CITY OF ALBUQUERQUE

**RE: Academy Dental Center
6421 Holly Ave NE
Revised Grading and Drainage Plan
Engineer's Stamp Date: 11/22/19
Hydrology File: C18D038A**

Based upon the information provided in your submittal received 12/02/2019, the Revised Grading and Drainage Plan is approved for Building Permit.

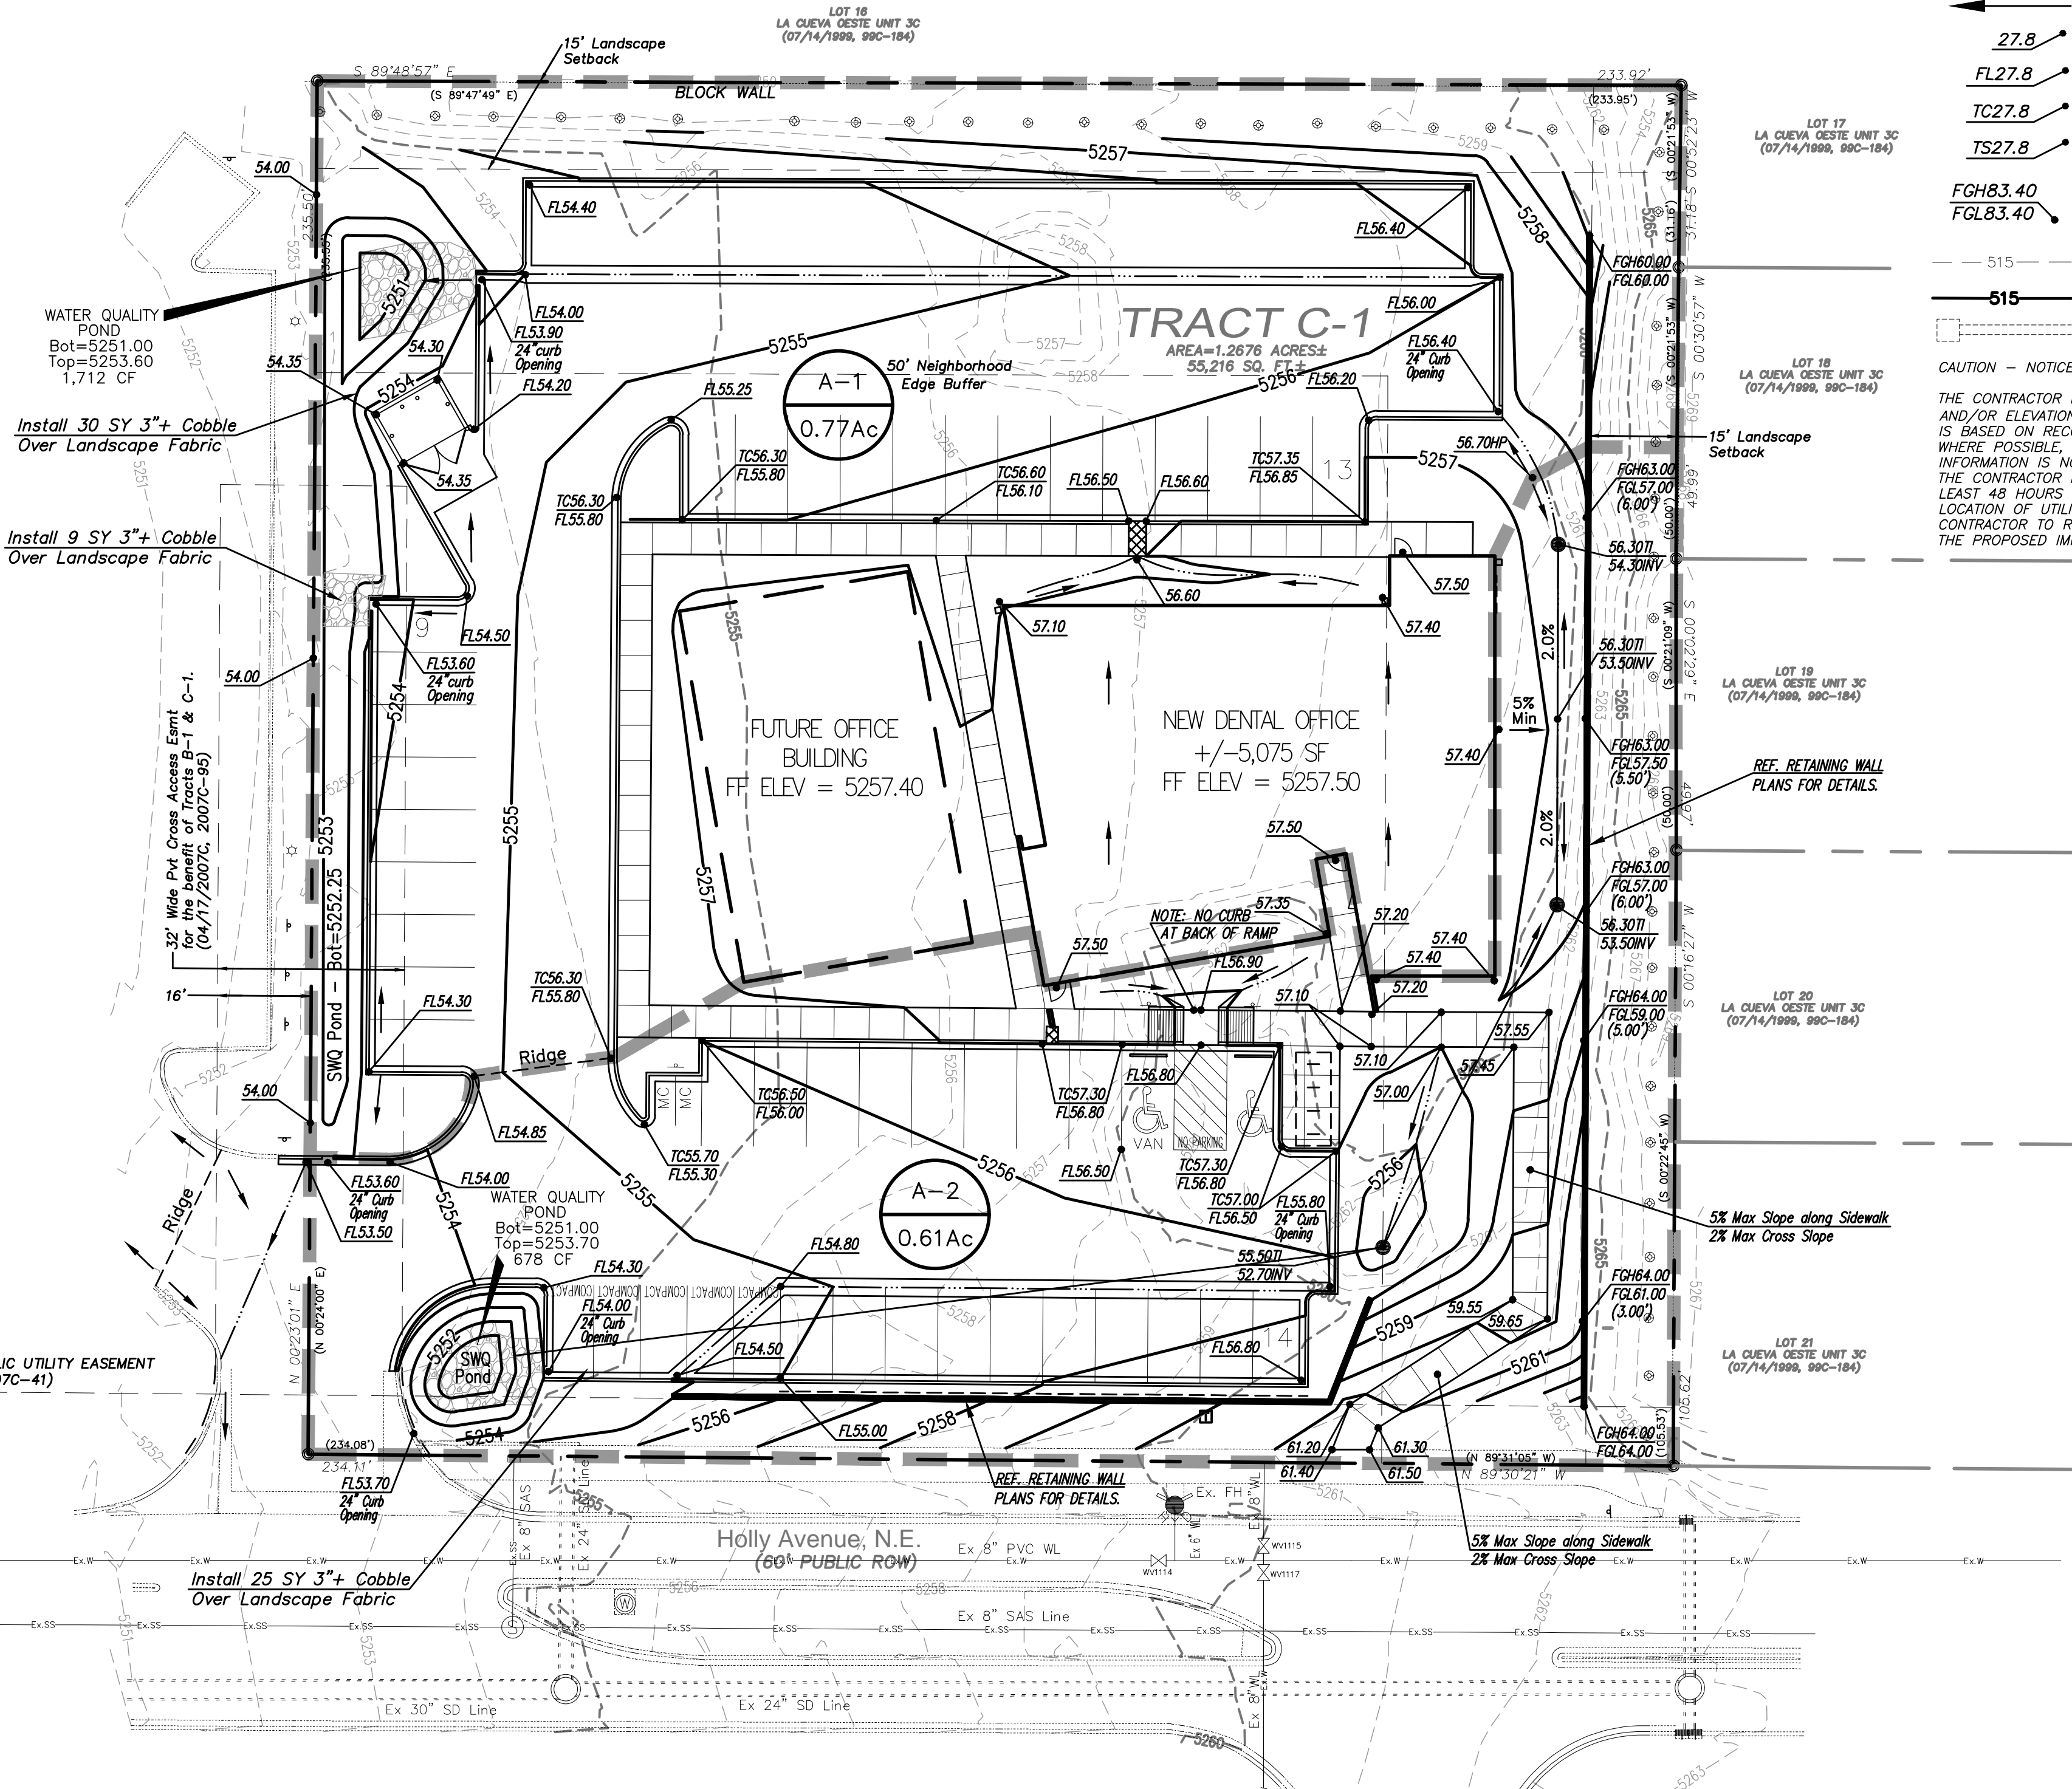
Please attach a copy of this approved plan in the construction sets for Building Permit processing along with a copy of this letter. Prior to approval in support of Permanent Release of Occupancy by Hydrology, Engineer Certification per the DPM checklist will be required.

If the project total area of disturbance (including the staging area and any work within the adjacent Right-of-Way) is 1 acre or more, then an Erosion and Sediment Control (ESC) Plan and Owner's certified Notice of Intent (NOI) is required to be submitted to the Stormwater Quality Engineer (Doug Hughes, PE, jhughes@cabq.gov, 924-3420) 14 days prior to any earth disturbance.

Please provide Drainage Covenant per Chapter 17 of the DPM prior to Permanent Release of Occupancy for the stormwater quality ponds. Please submit these to the 4th floor of Plaza de Sol. A \$25 fee for each will be required.
